UNITED STATES PATENT AND TRADEMARK OFFICE

APPLICATION NO.	FILING DATE	FIRST NAMED INVENTOR	ATTORNEY DOCKET NO.	CONFIRMATION NO.
09/531,735	03/21/2000	Shalom Levin	EPLC/03	7129
30954	7590	06/02/2006	EXAMINER	
LATHROP & GAGE LC 2345 GRAND AVENUE SUITE 2800 KANSAS CITY, MO 64108			KOVACS, ARPAD F	
			ART UNIT	PAPER NUMBER
			3671

Office Action Summary

DETAILED ACTION

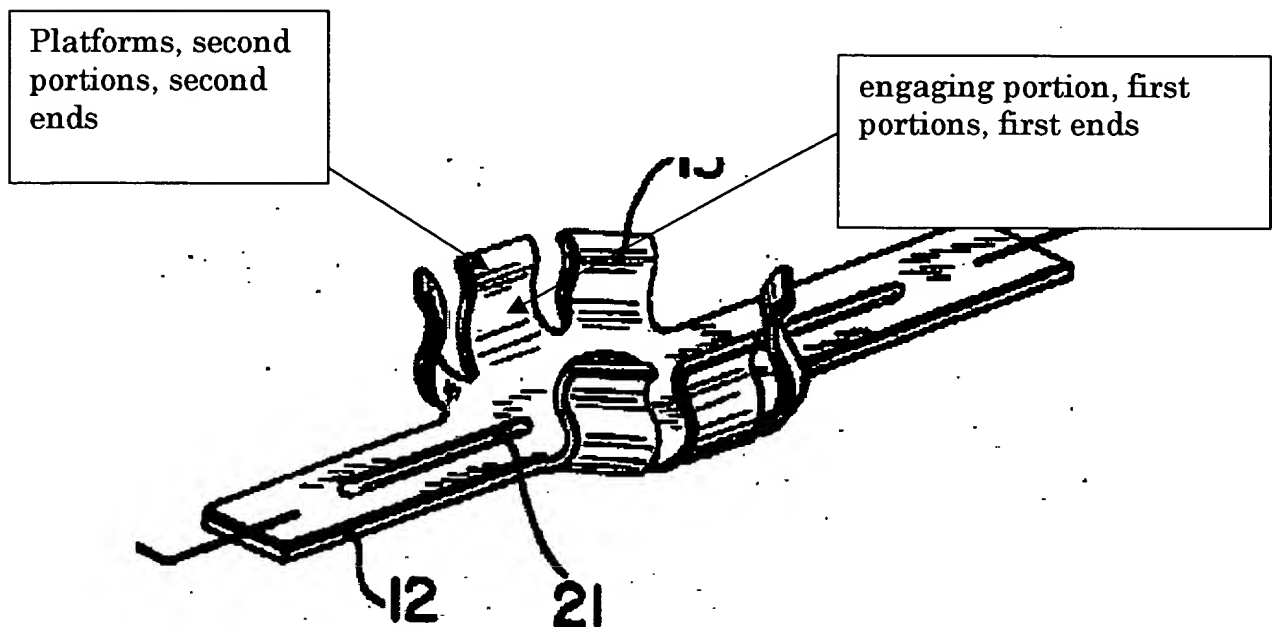
As shown in the marked up figures below, Weber discloses:

a shaft (15);

a stub (hub 14: groove 19 & cylindrical portion 20) in communication with shaft (fig 2);

a blade (12);

a receiver coupled to the blade (fig 2) including:

a receiving portion (central web 22);

flexible members (spring clips 13) including:

engaging portions and platforms disposed at opposite ends (see fig above);
